GEN 5 DD13 Turbo Oil Drain Tubes

PUBLISH DATE: 7/30/2024

Example of cracked turbo oil drain tube.

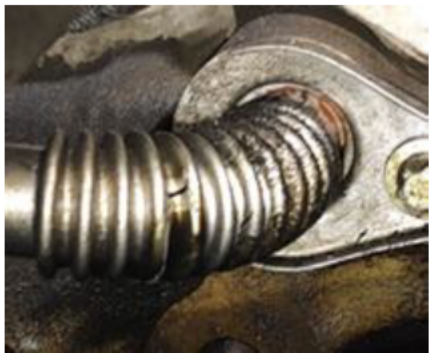
- Some Gen 5 DD13 turbo oil drain tubes are cracking and causing oil leaks. Missing or loose turbo support bracket bolts is the cause.

FIELD SOLUTION: Replace drain tube along with turbo mounting brackets and bolts.

- 1/24/25 - Turbo mounting bracket bolt torque was increased on the assembly line from 25NM to 30NM.
- These issues have been reduced. Further investigation is underway.

- For engines built before December of 2024, please reference the DD13 GEN 5 workshop manual, section 5.7.3 and be sure to follow step #2. For engines built on or after December 2024, please reference TSB-01-002-DDC.
